UNITED STATES PATENT AND TRADEMARK OFFICE

APPLICATION NO.	FILING DATE	FIRST NAMED INVENTOR	ATTORNEY DOCKET NO.	CONFIRMATION NO.
09/920,222	08/01/2001	Robert B. Davies	4151-A4	5846

Office Action Summary

DETAILED ACTION

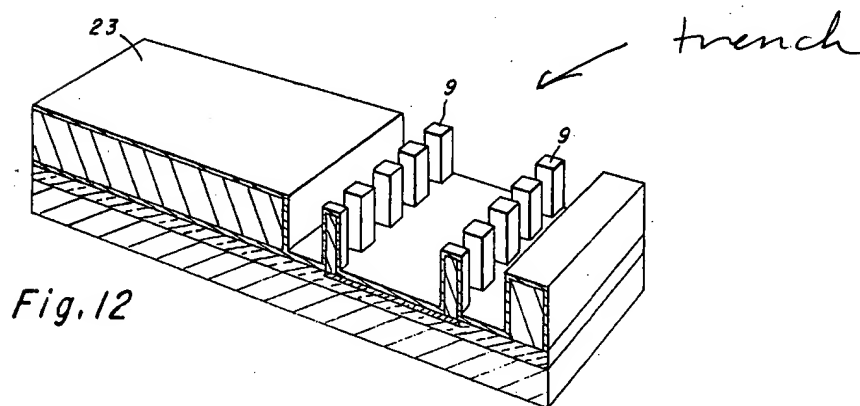
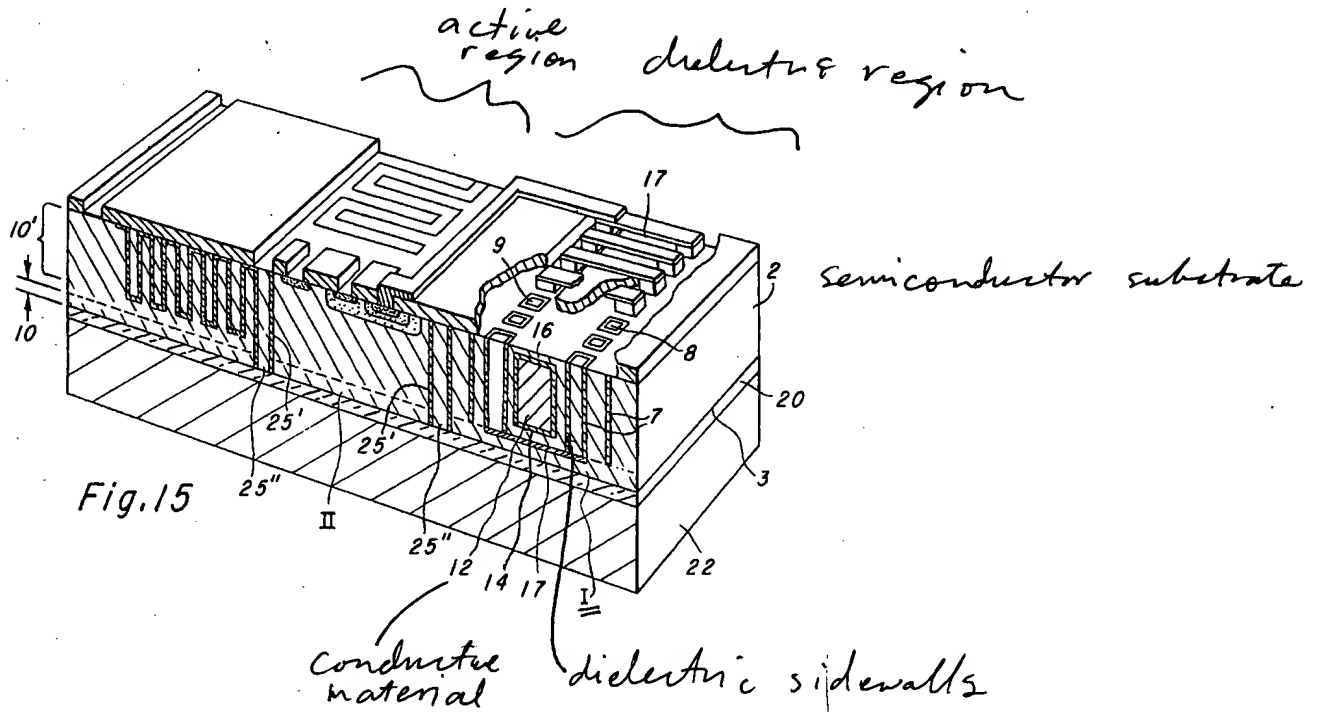
6. Claims 1 thru 3, 5 thru 7, 37 thru 40, 42, 43, 45, and 47 thru 50 are rejected under 35 U.S.C. 103(a) as being unpatentable over Kendall 3,881,244 in view of Riseman 4,169,000. Kendall discloses (see, for example, FIG. 15) an integrated circuit comprising a silicon substrate (low resistivity semiconductor substrate) 2, dielectric region, trench, oxide layer (dielectric sidewalls) 7, isolation region 25', and core material (conductive material) 12. The right side of the figure clearly shows an inductance I. Kendall does not disclose the isolation region 25' as a cavity. However, Riseman discloses (FIG. 7) an integrated circuit structure comprising a cavity 12. In column 4, lines 32-37, Riseman

Regarding claims 37, 38, 42, 43, 45 and 49, Kendall discloses (see, for example, FIG. 15) an integrated circuit comprising a silicon substrate (low resistivity semiconductor substrate) 2, transistor element (active region) II, dielectric region, transistor (active component), trench, oxide layer (side-walls) 7, and metal core (high conductivity electroplated material) 12. The dielectric region is the general area where isolation layer 14 is present (the area where the transistor is not). Multiple cavities are formed that include oxide layer 7 and layers 25'.

Regarding applicant’s argument on page 10, second paragraph that Kendall does not show a trench having dielectric sidewalls and the inductance bounded by the sidewalls, this argument is not persuasive. In Fig. 15, Kendall discloses an inductor core 12 that is bounded by the oxide layer (dielectric sidewalls) 7. The trench is more clearly shown in Fig. 12 wherein a trench is formed between the studs 9. The trench is then coated on its sidewalls by the oxide layer 7. See the 102 rejection (see the labeled figures in paragraph 6) above.
